| Title | Comments on Figure 270a | |
| Re: | IEEE 802.16j-07/043: "IEEE 802.16 Working Group Working Group Letter Ballot #28" | |
| Abstract | This contribution corrects Figure 270a in P80216j/D1. | |

Figure 270a—Example of configuration for an in-band transparent relay frame structure

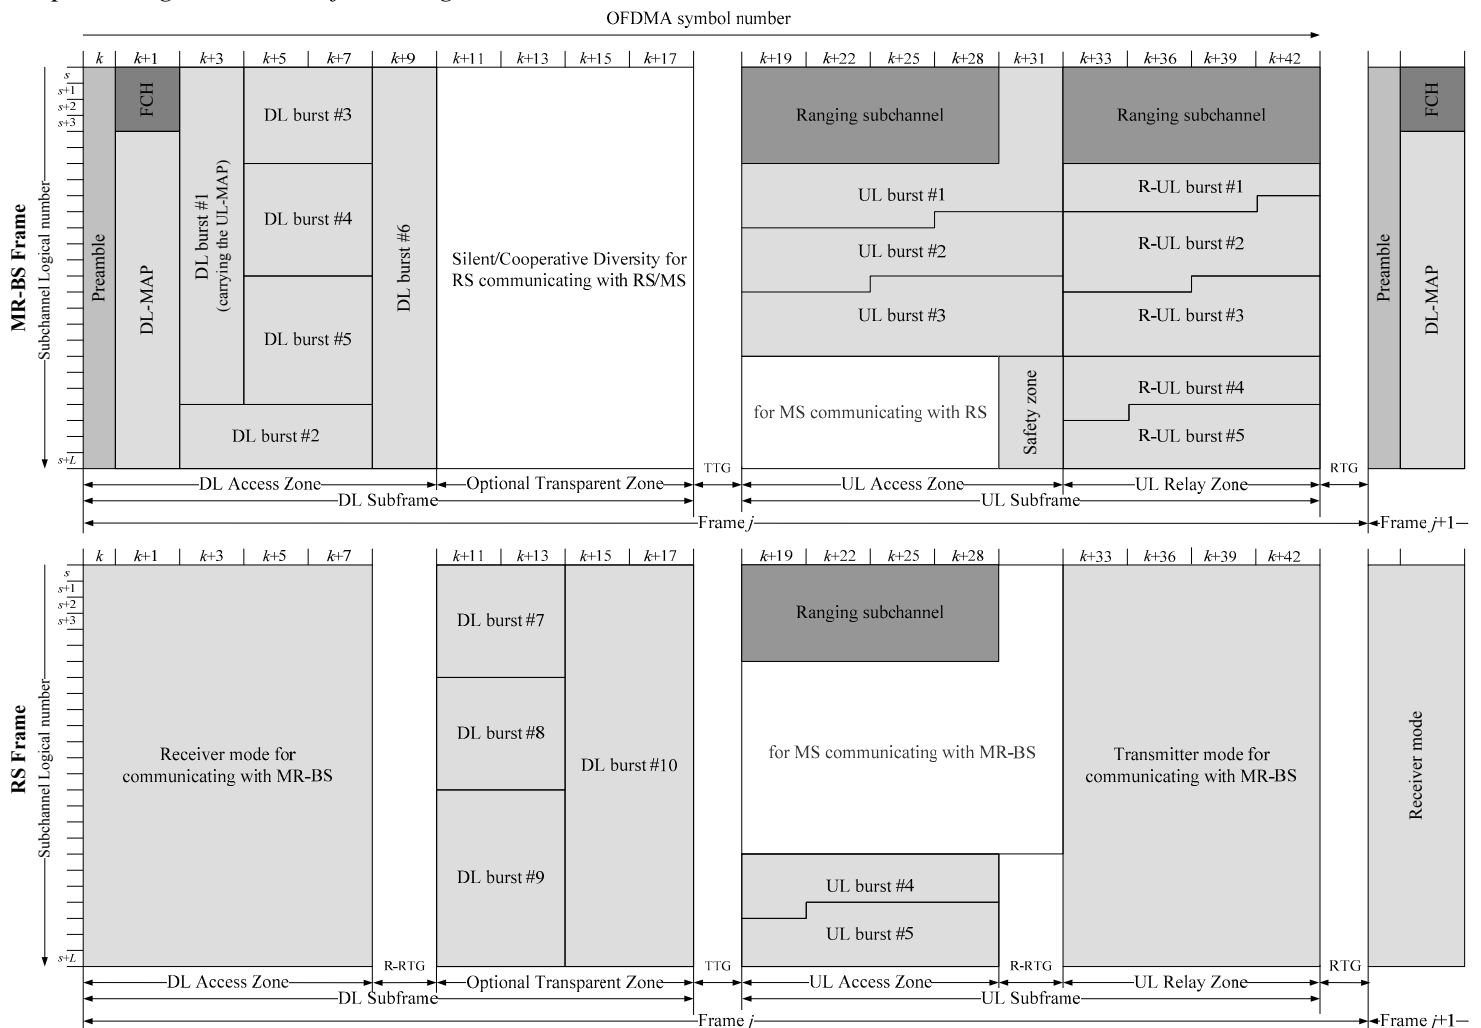
This contribution proposes remedy for the figure 270a in the draft standard P802.16j/D1. In current 270a frame structure example, the RS cannot monitor the Ranging during the R-RTG interval. Therefore the MS that transmit to BS the ranging codes during the R-RTG cannot be detected by the RS. So, the ranging region of the BS has to shrink to match that of RS.

There is also a problem with data bursts. If the UL subframe tells the MS that the access zone starts at $k+19$ and ends at $k+31$ then the MS will transmit from left to right during the entire interval. Because the MS is not aware of the RS, what is represented at UL burst #4 and #5 in the RS Frame that span from $k+19$ to $k+28$ are actually spanning from $k+19$ to $k+31$ as shows in MR-BS Frame of the figure 270a. This kills the R-RTG, or the RS cannot receive the bursts correctly. Thus, a safety zone is required to safeguard R-RTG.

[Replace Figure 270a as following indicated:]
